## PCN

### New label for B3237\* series of EPCOS MKD AC power capacitors from Zhuhai FTZ

<b>1. ID No.</b> FILM P19-16		<b>2. Date of announcement</b> October 4, 2019	
<b>3. Product / product group</b> EPCOS Power Electronic Capacitors MKD AC B3237*	<b>Old ordering code</b> B3237*	<b>New ordering code</b> No change	<b>Customer part number</b> n/a
<b>4. Description of change</b> In order to unify our layout on the capacitor labels, we will introduce the following changes: 1) B32377*, type B (600 V rms~1000 V rms) and type C (250 V rms~1000 V rms): Add UL logo 2) B32377*: Add type "A, B, C" information (according to UL requirment) 3) B3237*: Move barcode postion from bottom to the right side 4) B3237*: Change voltage symbol from 'U' to 'V'			
<b>5. Effect on the product or for the customer (benefit, quality, specification, lead time)</b> Only the printing layout on the label will change, as described above.			
<b>6. Quality assurance measures / risk assessment</b> Quality procedures will remain unchanged

**Annex to UPtoDATE 191004PC1 and PCN FILM P19-16 of October 4, 2019**  
**New label for B3237\* series of EPCOS MKD AC power capacitors from Zhuhai FTZ**

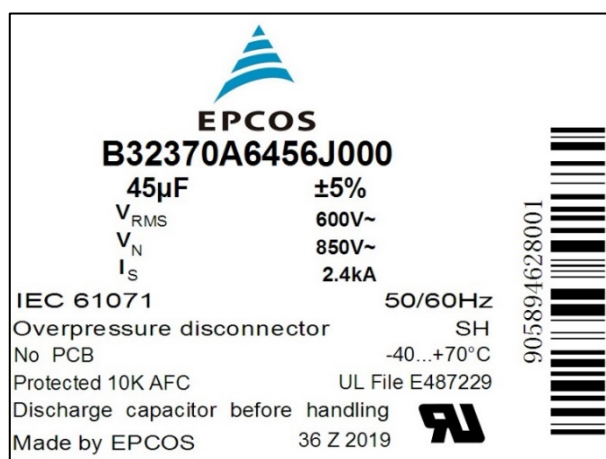
B32377*	UL logo added for type B (600 V <sub>rms</sub> ~1000 V <sub>rms</sub> ) and type C (250 V <sub>rms</sub> ~1000 V <sub>rms</sub> )
B32377*	"A, B, C" information added (according to UL requirement)
B3237*	Barcode position moved from bottom to the right side
B3237*	Voltage symbol changed from 'U' to 'V'
